CONSTRUCTION OF

SIDEWALK / DRIVEWAY

Permit Number: 11804

Driveway Review Form

Sketch

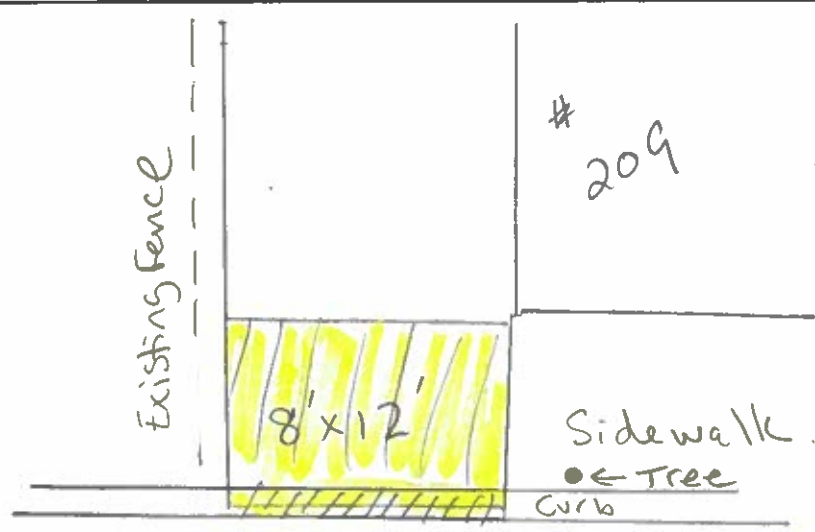
1. Remove 12 FT of granite Curb.
2. Remove 8 FT wide x 12 FT long Sidewalk
3. Install 8 FT wide x 12 FT long Cement concrete Apron According To City of New Bedford DPI Specs
4. Tree is NOT 10 FT from Driveway. Tree will be removed and Home owner must Donate 2 Trees back To Neighborhood.

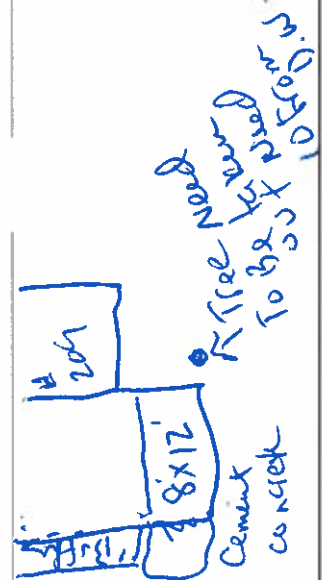
Call Brandon on How many Trees To Donate Need To Purchase 2 I need To Replace one In front of House.
